11 SURFACE WATER

11.1 SURFACE WATER MANAGEMENT

11.2 ROCK STORAGE FACILITY

11.2.1 MODELLING OF RUN-OFF WATER FLOW AND QUALITY

Figure 11.1 Case 1: Estimated run-off volumes for five-minute duration events

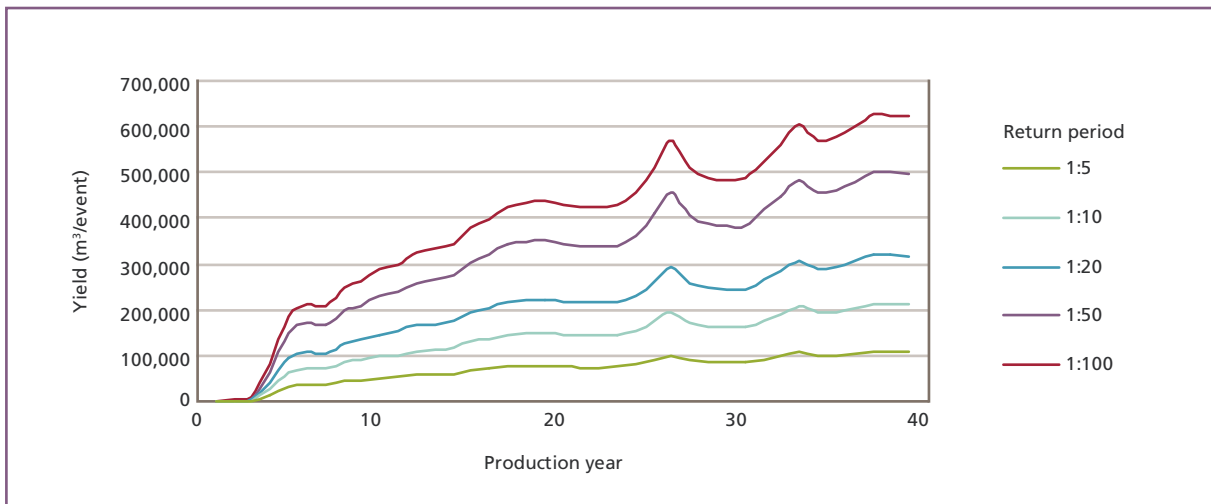
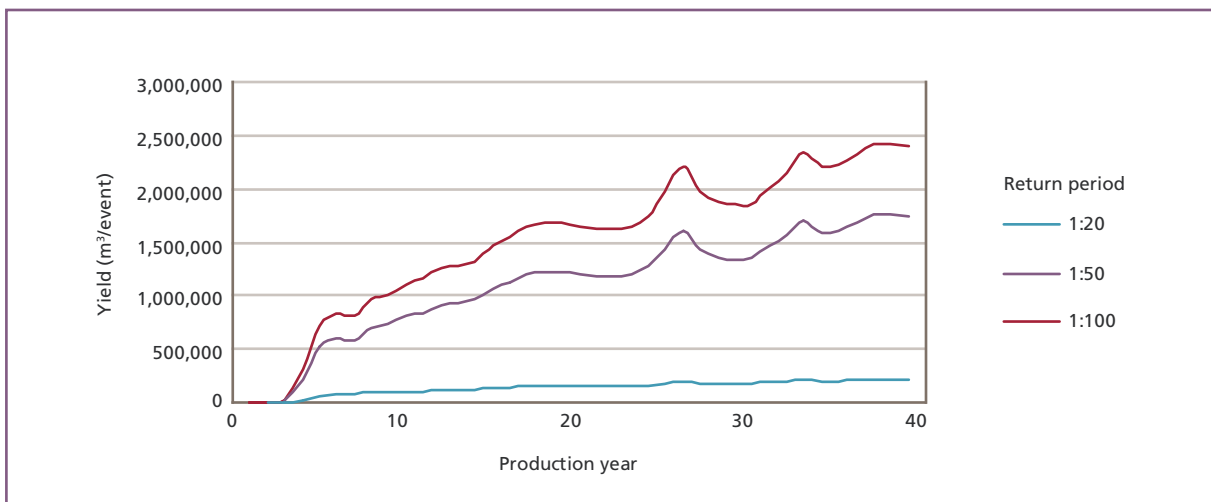
Further information was requested to characterise the water quality and management of potential run-off from the rock storage facility (RSF) and low-grade ore stockpile (LGS), during operation and closure. This information was requested to aid the interpretation of potential impacts on ecosystems in the surrounding swales and to assess the effectiveness of proposed management measures.

The volume of run-off that could be generated throughout the life of the RSF was estimated from the area of exposure of each rock type and adding together the flows from each area to provide the sum total flow from the RSF. The results are illustrated in Figures 11.1 and 11.2, for the short- and longer-duration events respectively. Note that for the short-duration events (0.083 hours or five minutes) with a return period of less than 1 in 5 years, no run-off would occur. For the longer-duration events (two hours), run-off would not be expected for events with a return period of less than 1 in 20 years.

As shown in Figures 11.1 and 11.2, while the very short-duration events may generate run-off for the shorter return periods, the total volume of water that would be generated is very small. For example, the run-off generated by a 1-in-100-year storm event lasting five minutes would be less than 700,000 m³ at the end of the RSF life, when its footprint area would be at a maximum. The total rainfall that would occur during such an event (1-in-100-year – 0.083-hour storm) is only about 17 mm, for which only a part of the RSF would yield run-off. It should be noted that a rainfall intensity of 204 mm/h was stated in Table 8.2 of the Draft EIS, however the total rainfall of 17 mm for the same event is the rainfall intensity (204 mm/h) multiplied by the duration of the event (0.083 h). Therefore, very little run-off would actually be expected to occur due to surface undulations, local ponding and attenuation. Note that in the Draft EIS the run-off was estimated using a fixed run-off coefficient of 0.75 for all materials to be placed in the RSF; as indicated by the modelling, the actual run-off is predicted to vary by material and rainfall intensity and duration. The Draft EIS therefore overestimates the modelled run-off that would be expected to occur.

The longer-duration events would generate flows only at the longer return periods of 1 in 20 years and above. As noted above, not all of the run-off that could be generated would be expected to flow to the surrounding natural terrain since flows would be ponded on the surface of the facility due to surface imperfections and depressions and would then evaporate or infiltrate (see below for further details). Disregarding flow attenuation on the surface of the facility (i.e. water ponding in shallow depressions on the surface of the RSF and being prevented from flowing off the surface), the maximum estimated volume of run-off that would need to be contained would occur when the RSF was at its full extent and the volume would be about 2.5 million m³. As noted in Chapter 11 of the Draft EIS, the 1-in-100-year event run-off could be readily contained within the sub-catchments of the expanded SML.

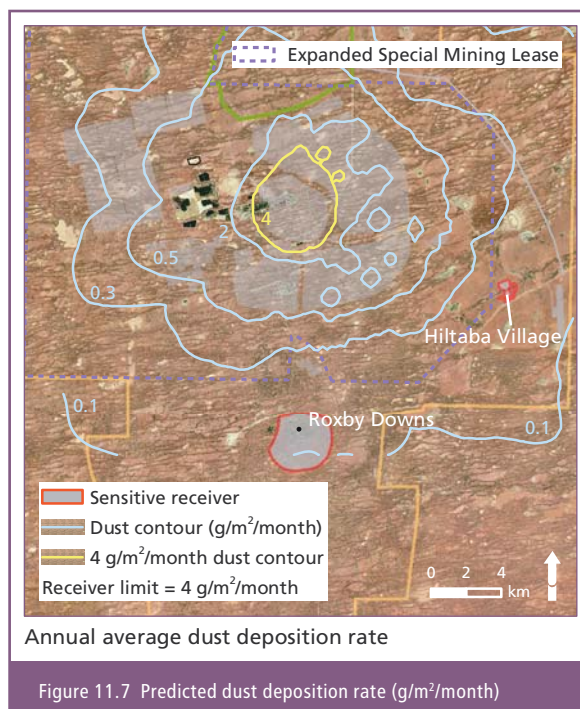
Further information was sought on the potential for acidic run-off to occur from the rock storage facility (RSF) and the impact of stormwater run-off and dust leachability on ecosystems in the natural swales or clay pans in and around the expanded Special Mining Lease.

The predicted extent of the area at or above the maximum deposition limit of 4 g/m²/month was shown in Figure 13.18d of the Draft EIS (updated and reproduced here as Figure 11.7). This indicates that this area would include only the open pit mine, part of the RSF and part of the mineral processing area. The area is not predicted to impact Arid Recovery or significant areas beyond the proposed disturbance footprints.
